APPENDIX J

HAZARDOUS, TOXIC AND RADIOLOGICAL WASTE (HTRW)

Figure 5. Area 5 Site Plan with Actual Sampling Locations and Construction Elements.

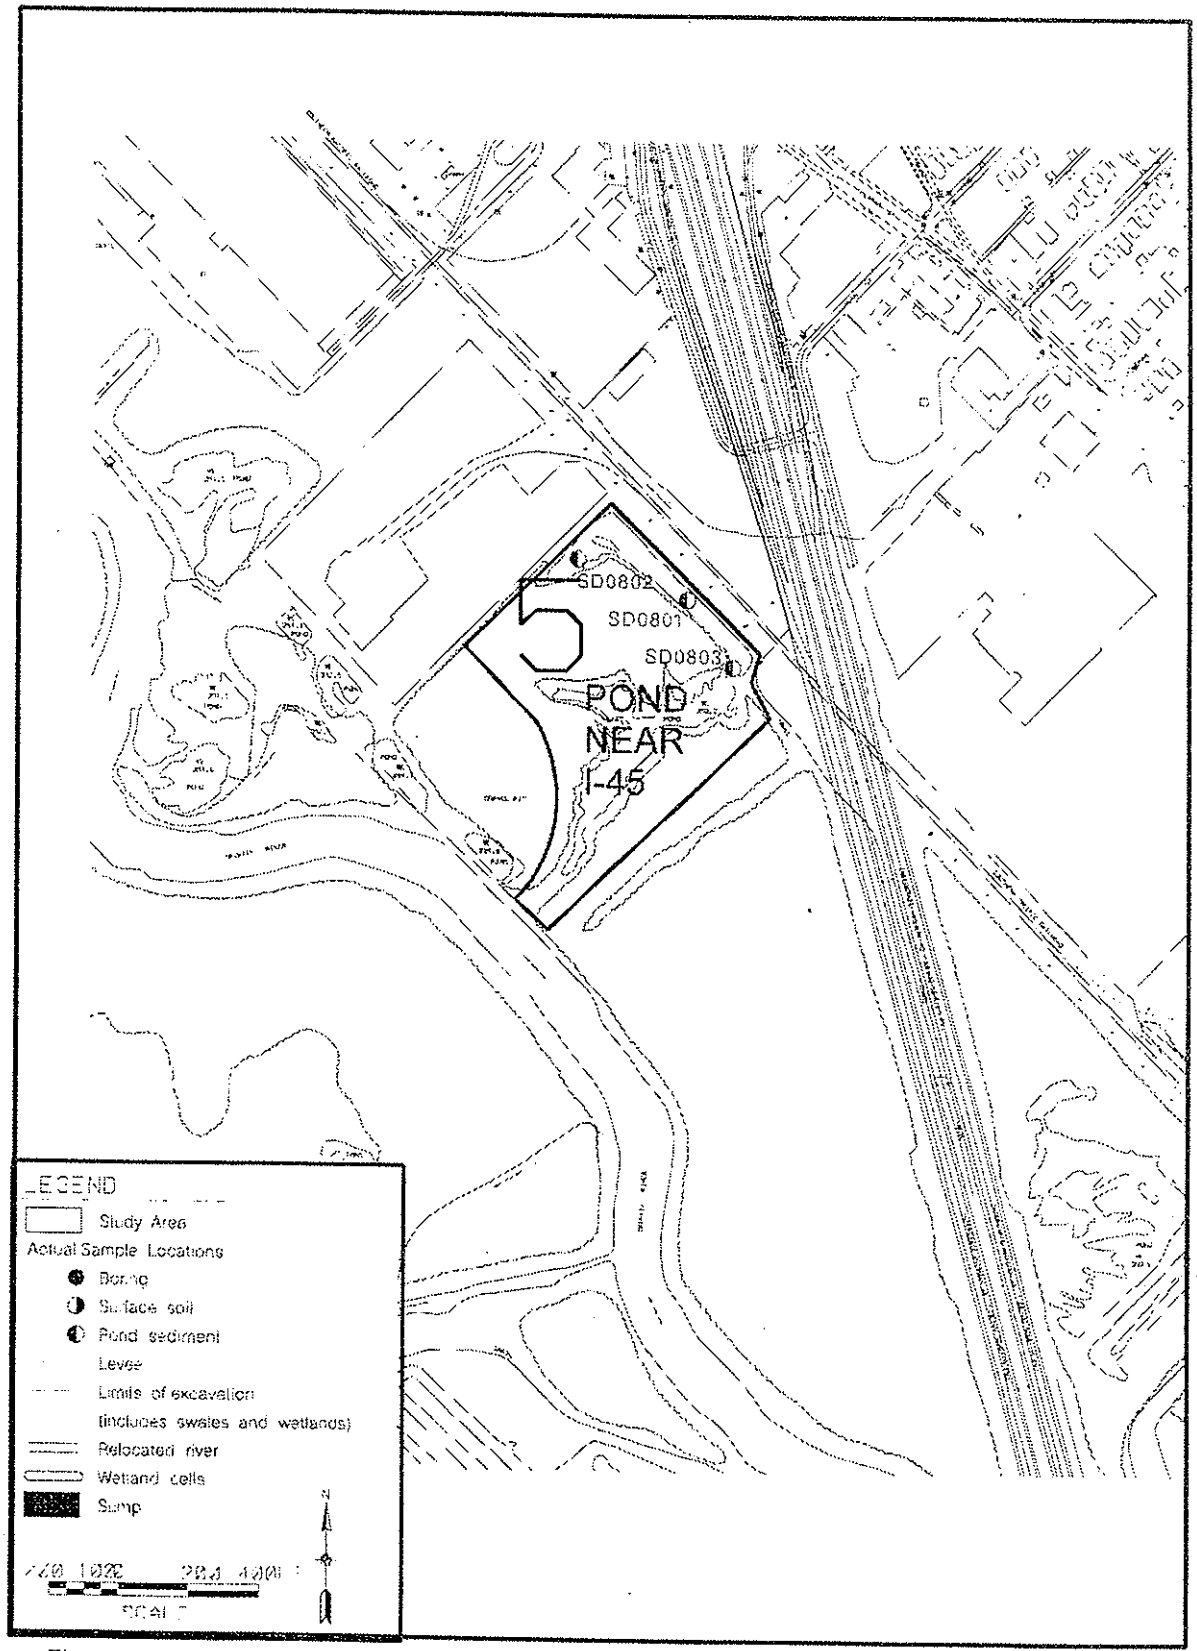
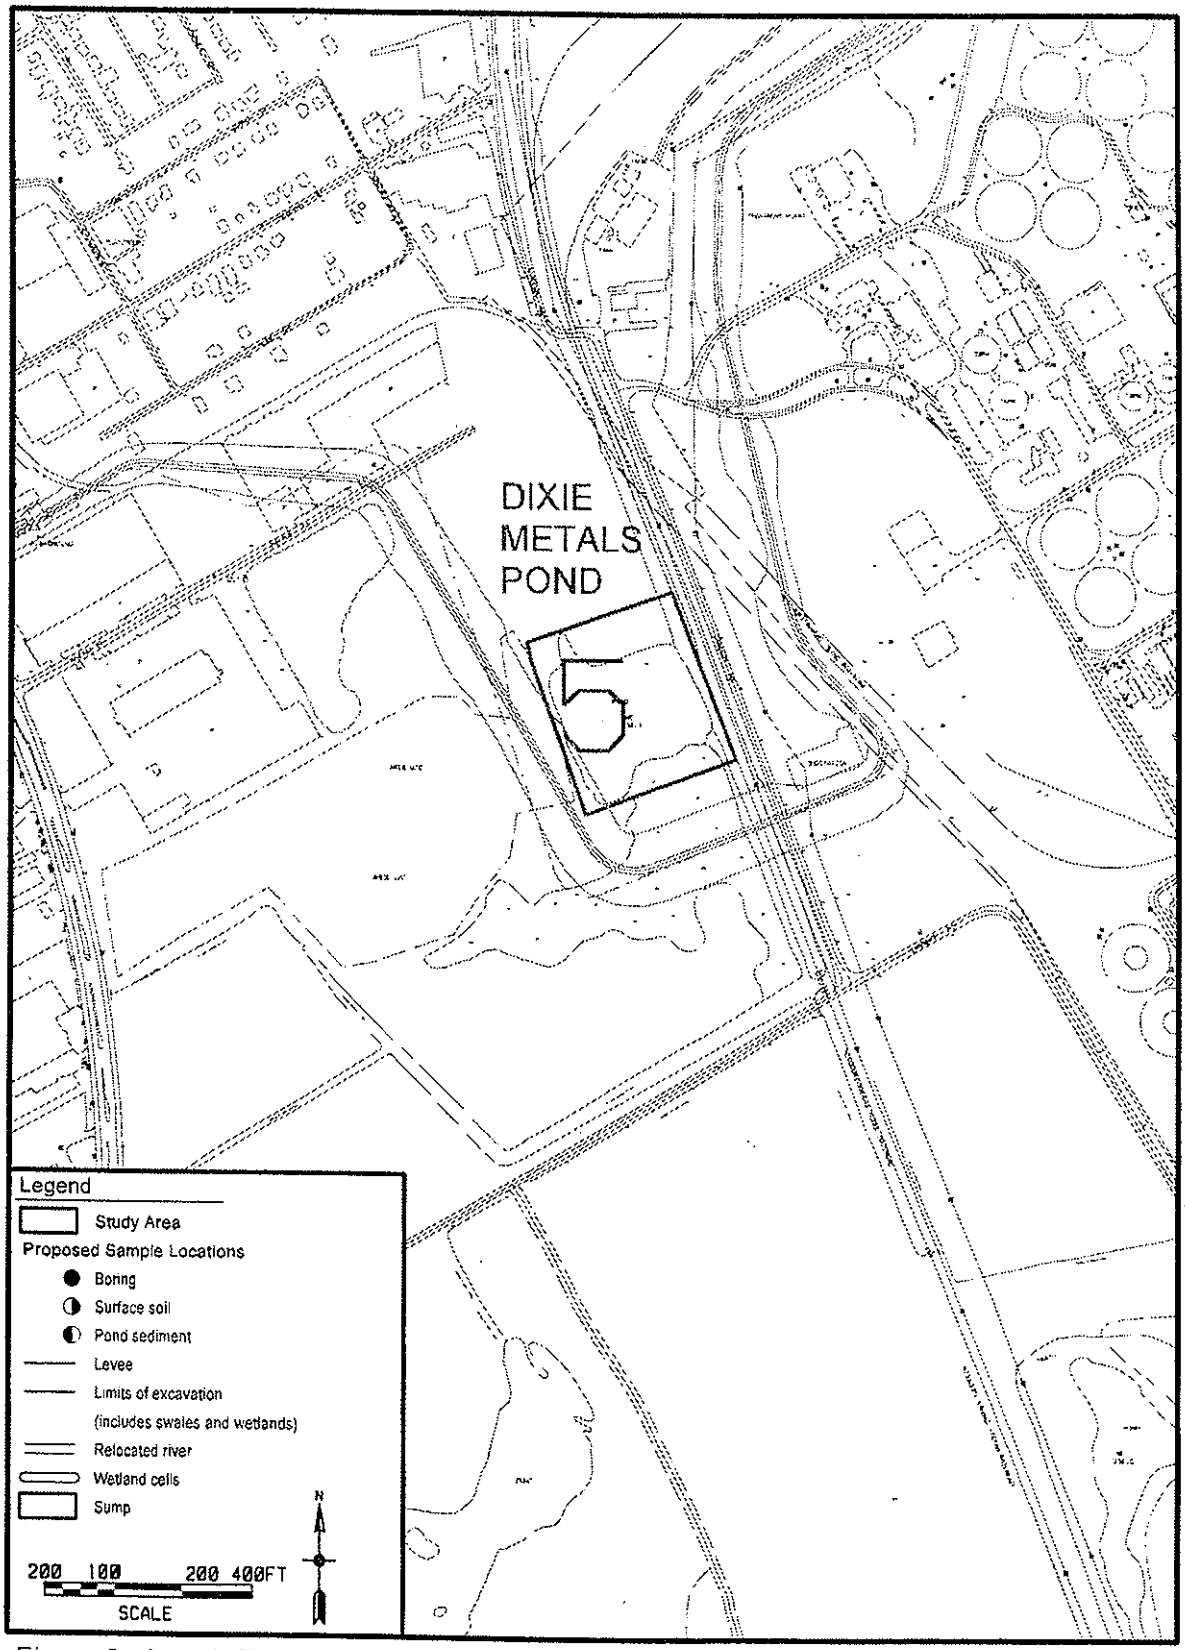
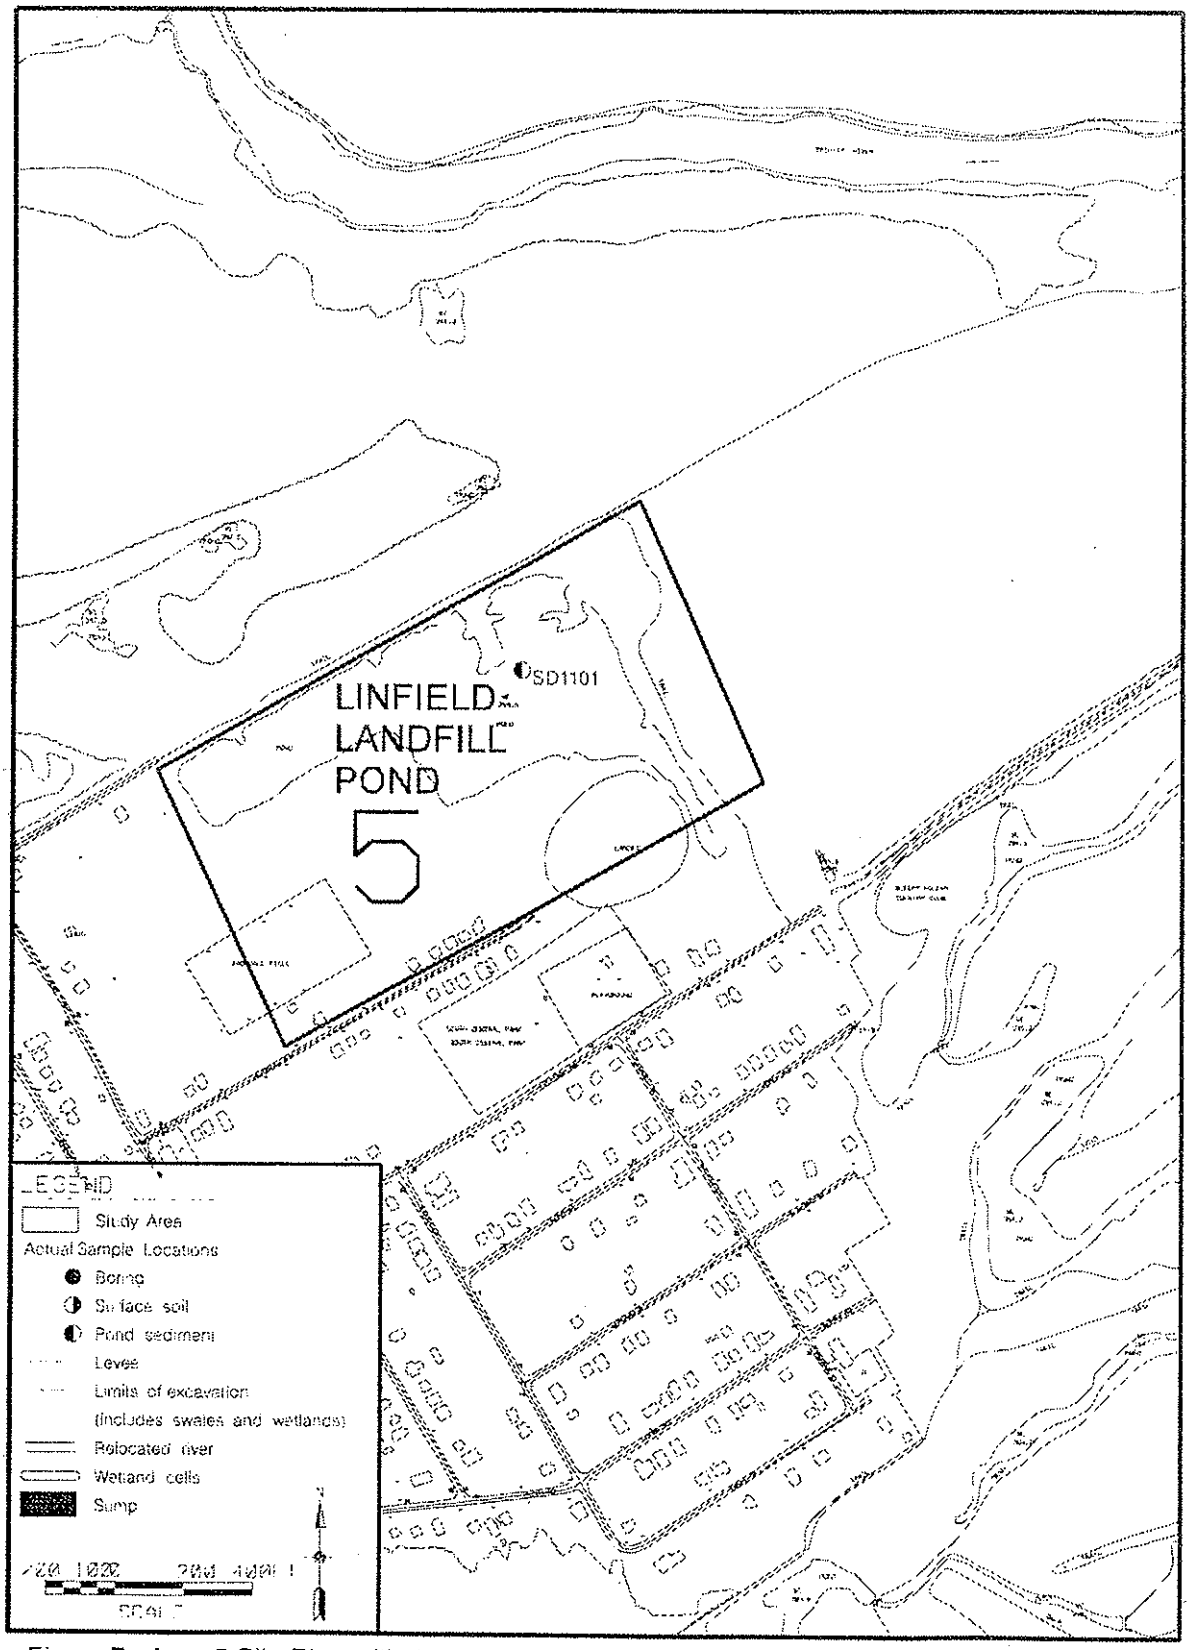
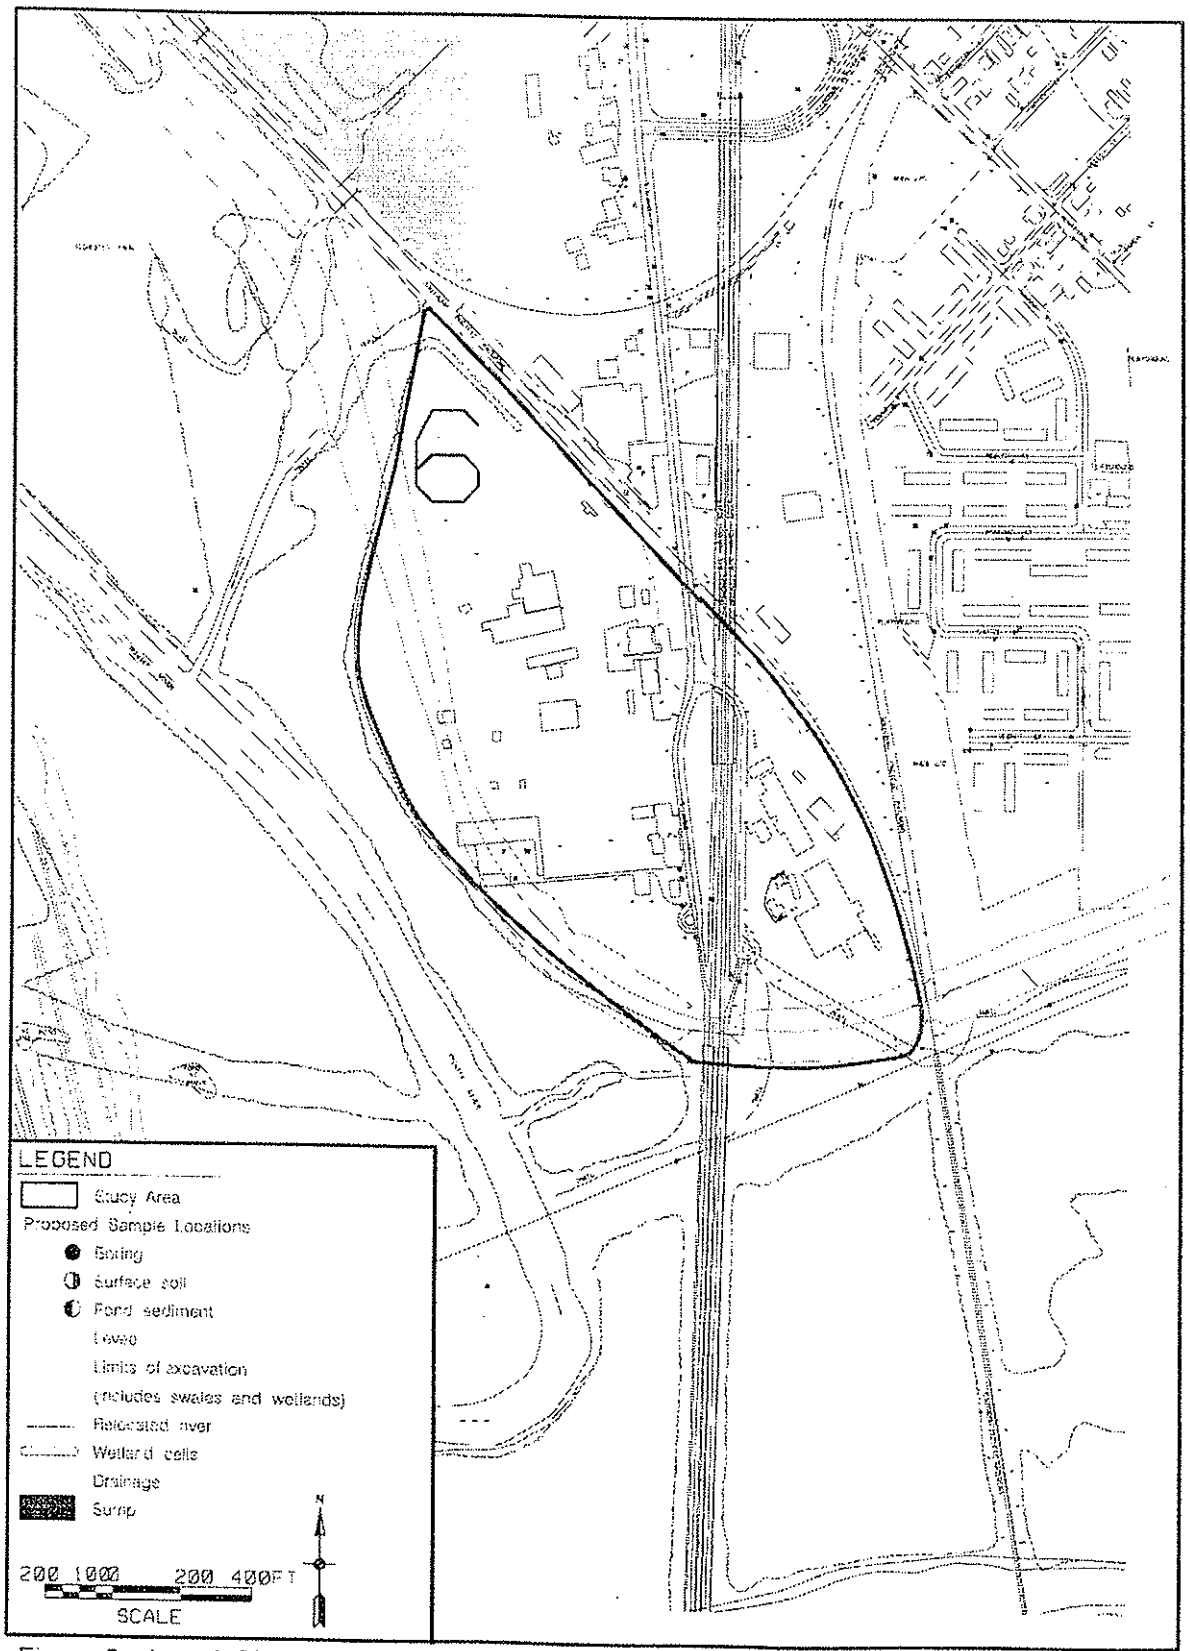
186. Appendix J, Figure 1 Area 1 through Figure 11 Area 13 are not clear and do not adequately show locations and addresses of borings made. The figures do not show borings taken from surface soil, swales, COWs, levees, sumps.

183. The locations of these areas are shown in figure 1, immediately prior to Section J-1, and in Section J-1 of Appendix J.
